EXCERPT

**The Proposed Broadwater LNG Import Terminal
Update of Synapse Analysis**

January 19, 2007

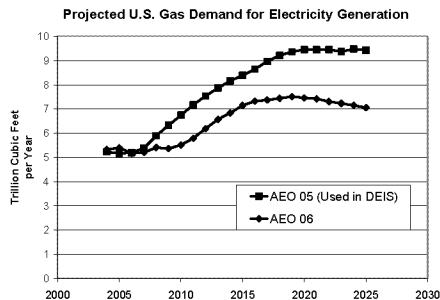
None of these recent events has altered our basic conclusion, that the Broadwater terminal is not required to meet the future energy needs of New York and Connecticut. To the contrary, both of our most basic conclusions have been strengthened. The newer forecasts for gas demand over the next two decades have been revised significantly downward relative to previously available forecasts, largely due to the disappearance of additional gas-fired electricity generation from utility resource plans. This change in projected gas demand for electricity generation is shown in the figure below.
